PCN – Process Change Notification

Change:	OMB.915.B03F21
Date:	2017/07/07
Author	Bonnie Chen

Model#	Part Number	Changes
915MHz 3.5dBi Omni Antenna, with N Type Female Connector, U- Bolt, 318mm Length Ø70*35mm	OMB.915.B03F21	 Amend Antenna Length. Amend Details of drawing.

Illustration of Change

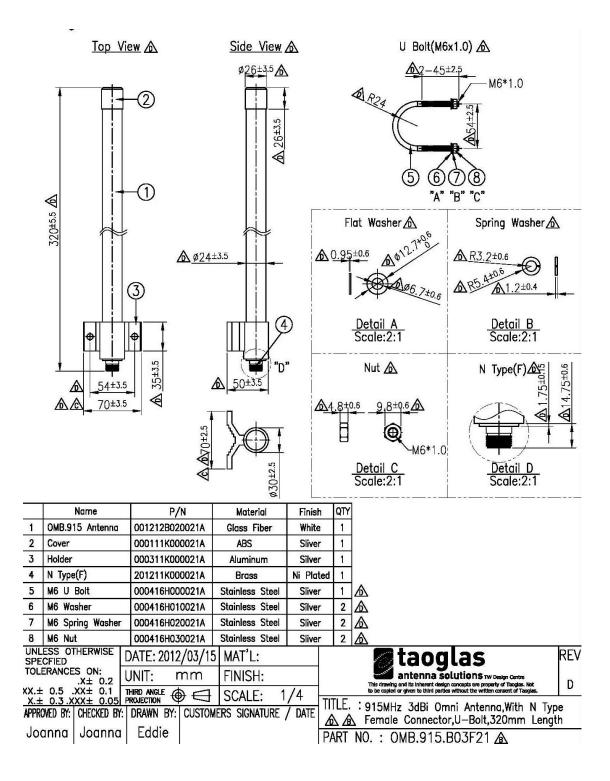
- 1. Amend Antenna Length from 320mm to 318mm.
- 2. Remove Washer and Nut dimenisons.
- 3. Amend BOM.
- 4. Amend Title of drawing.
- 5. Add Dimensions.
